DESCRIPTIVE REPORT
(HYDROGRAPHIC)

Type of Survey HYDROGRAPHIC
Field No. RA-10-3-77
Office No..... H-9711

State ALASKA
General Locality PRINCE WILLIAM SOUND
Locality JACK BAY

H-9711

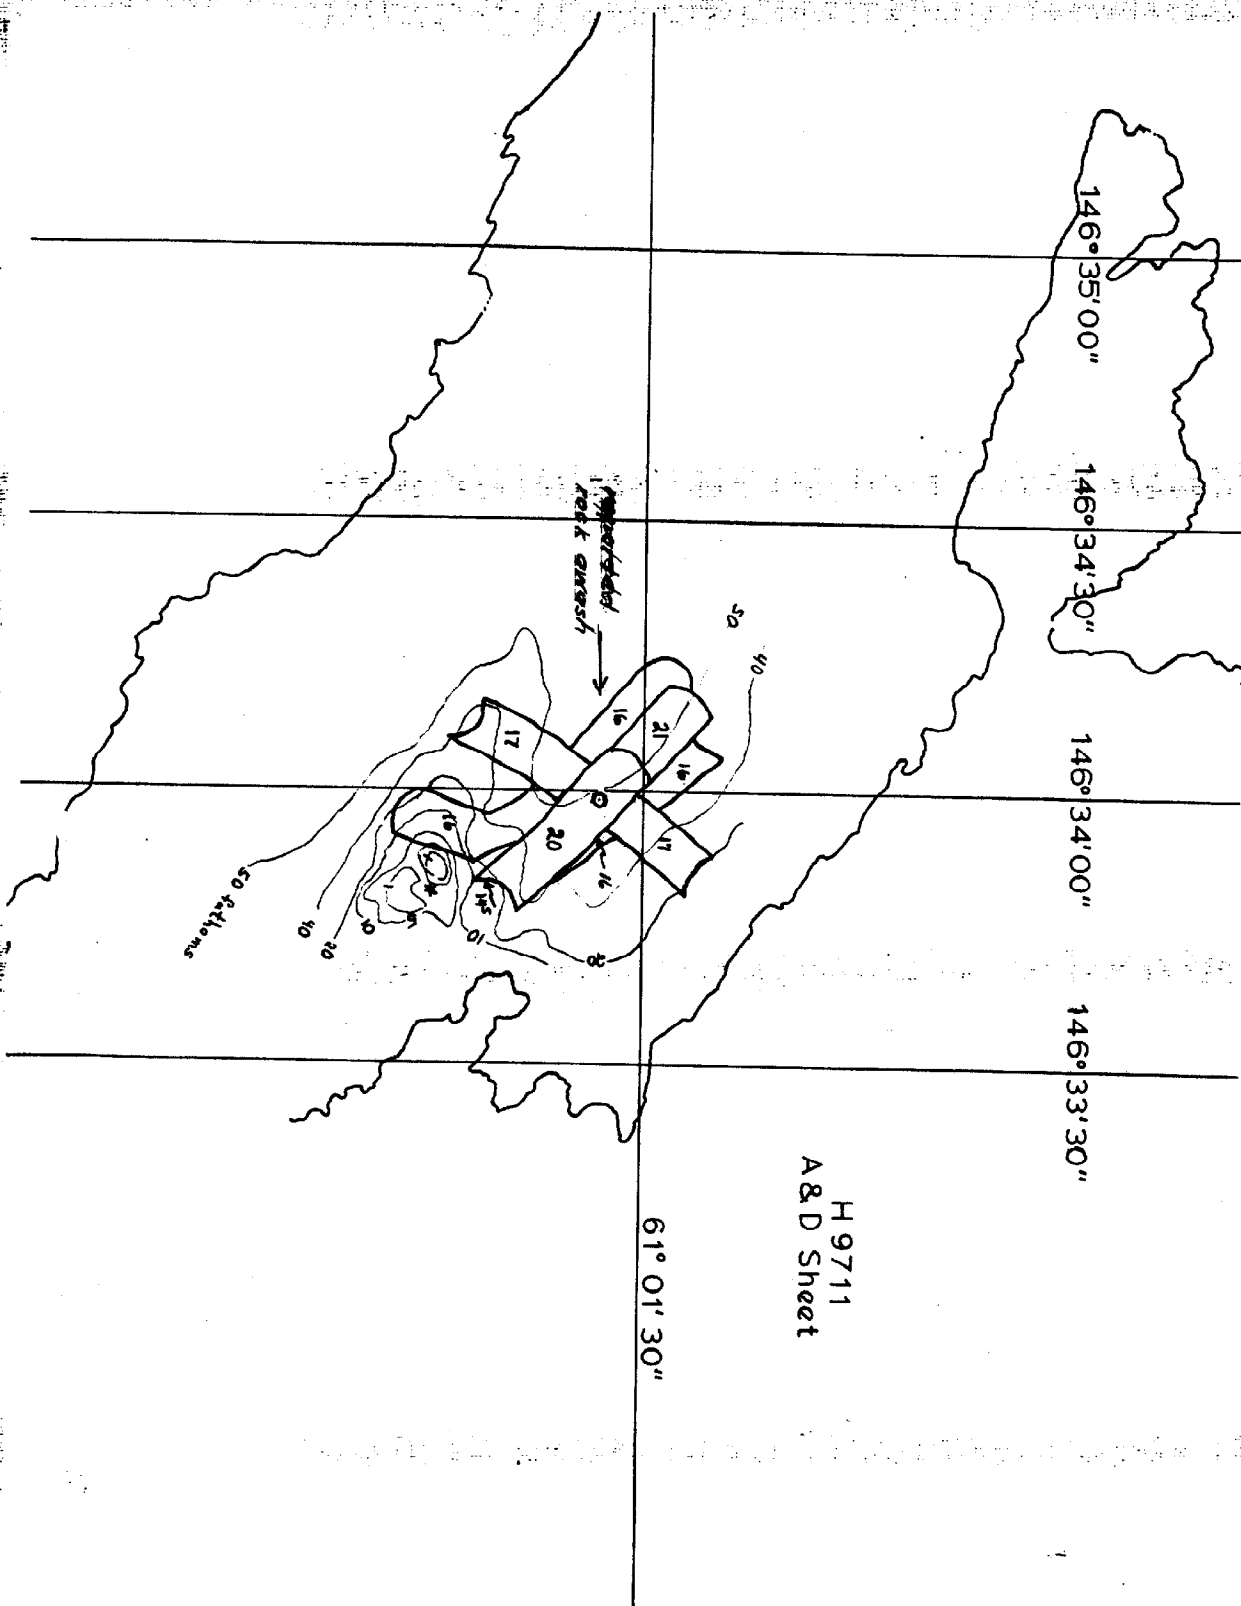
Using the upright lengths minus predicted tides (Cordova), conservatively, the six sweep strips produced effective depths that ranged from sixteen to twenty feet below chart datum. Smooth plot overlaps at the scale of H-9711 were prepared for each sweep strip. The red outlined area on each sweep strip is the estimated effective area of coverage, as determined by a scaled mylar strip representing the length of wire payed out and curved to a normal bite so that end buoy positions could be estimated relative to the launch position plots. Using the area outlined in red and the depth determined by predicted tides, an Area and Depth Diagram was constructed showing the total effective coverage of the combined sweeps. Sufficient sweep strip overlap was provided for all sweep paths across the reported rock to allow for reduced effective width.

It is recommended that the rock awash symbol appearing on H-9711 at latitude $61^{\circ}01'27''$ and longitude $146^{\circ}34'00''$ be removed.

H 9711
A & D Sheet

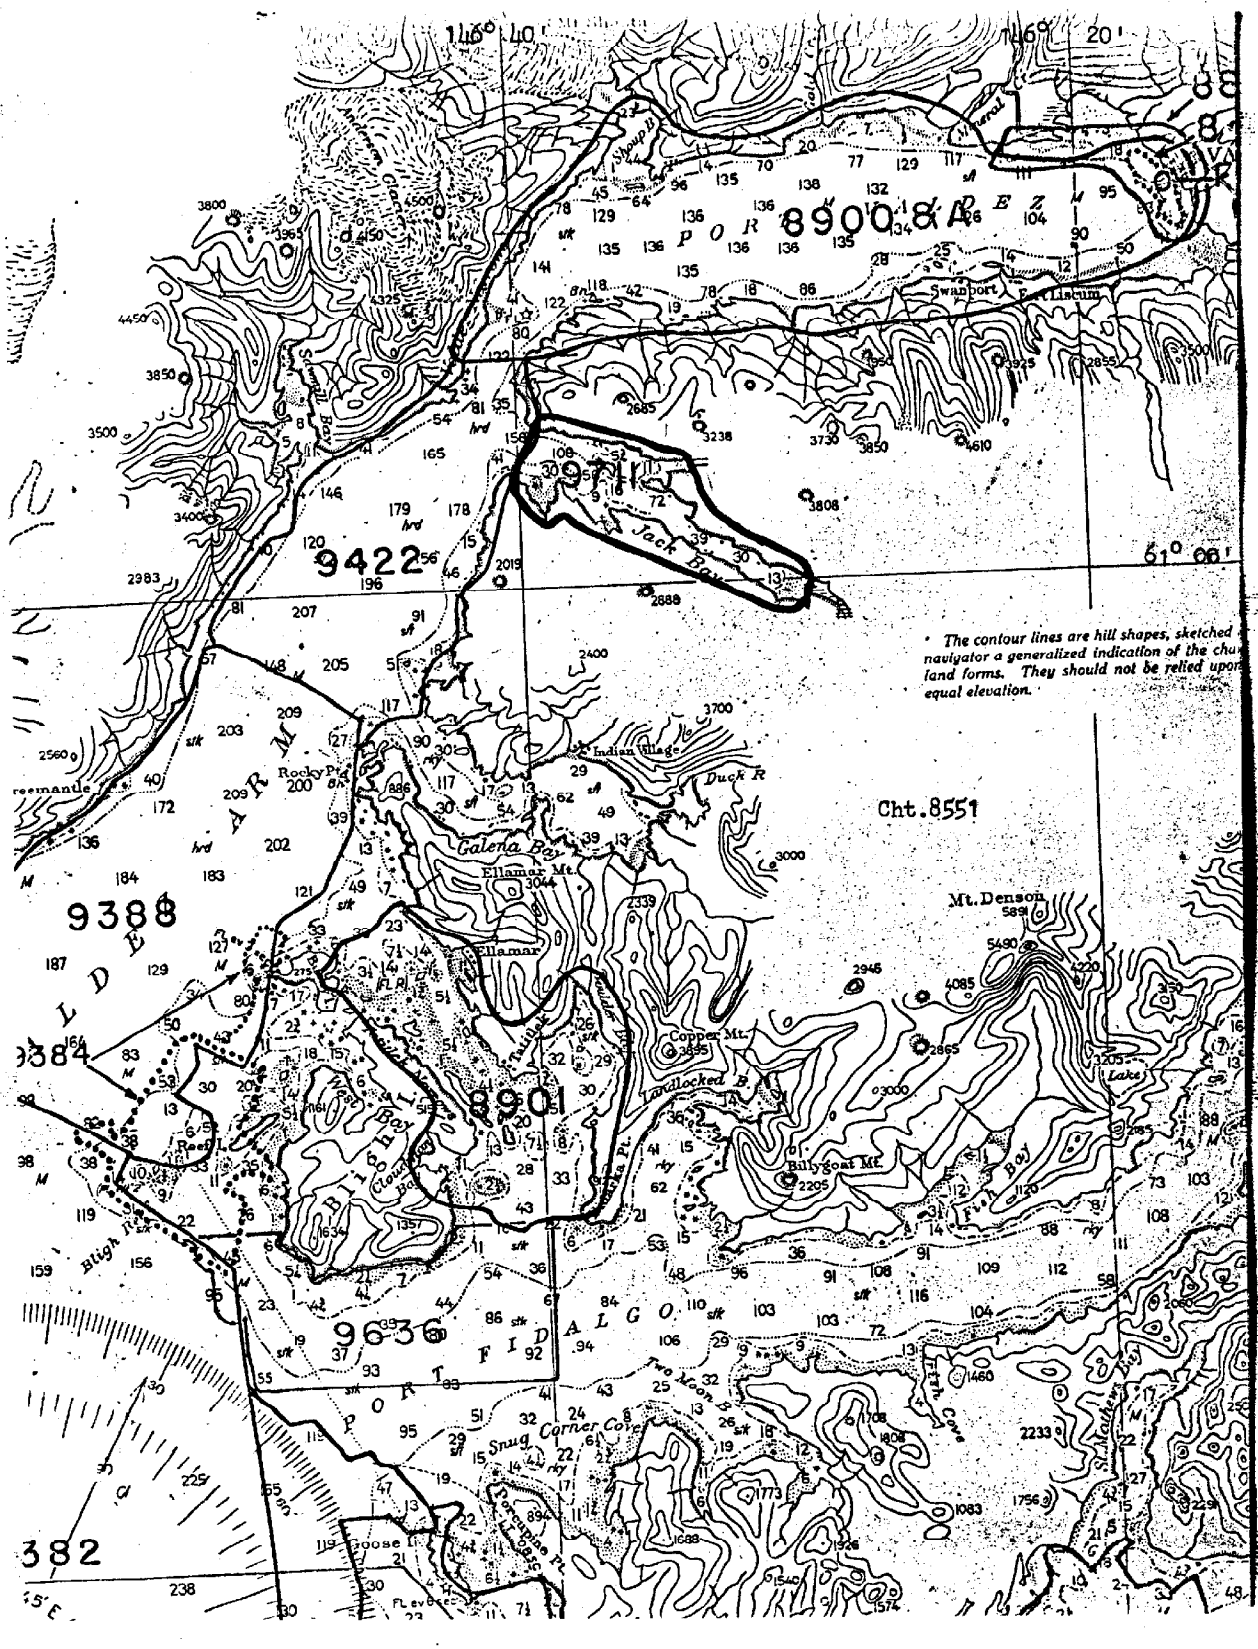
There is a questionable 4 foot rock and foul area on the present survey at approximate Lat. 61°01'27", Long. 146°34'00". This rock is located between two lines of hydrography with 50 meter spacing in 48-50 fathoms depths. The hydrographic records do not show any data pertaining to the rock. Its apparent source is a field identification on photo 65L4397 per Al Rauck, Coastal Mapping Division, 31 January 1978. The verifier recommends that this rock be charted as plotted. *do not concur, see Q.C. Critique 785 Rock disproved by 1978 W.D. investigation*

The Hydrographic Inspection Team cannot reach a consensus as to the validity of the data indicating a shoal and culminating with a rock at Latitude 61°01'27" and Longitude 146°34'00". The rock, in question, was not shown on the ship's final field sheet. Additional work is recommended to develop or disprove the shoal and should be accomplished by Ship MCARTHUR during their work in Prince William Sound early in the summer of 1978. Until the status of this rock is finitely determined, it should be charted as shown on the smooth sounding sheet.

7. A rock awash uncovering 4 feet at MLLW and accompanied with foul limits in latitude $61^{\circ}01.46'$, longitude $146^{\circ}33.98'$ on T-12993 (1965-77) was originally transferred to the smooth sheet during verification. This rock reportedly was not seen on the photographs, but was added by the field editor. Further investigation was verbally reported as done in 1978 with negative results. Two lines of hydrography, spaced 50 meters apart, straddle this alleged rock. An examination of the fathograms reveals no evidence of the rock, recording 48- to 50-fathom depths in this area. Because of this, the alleged rock was removed from the survey and is considered nonexistent.
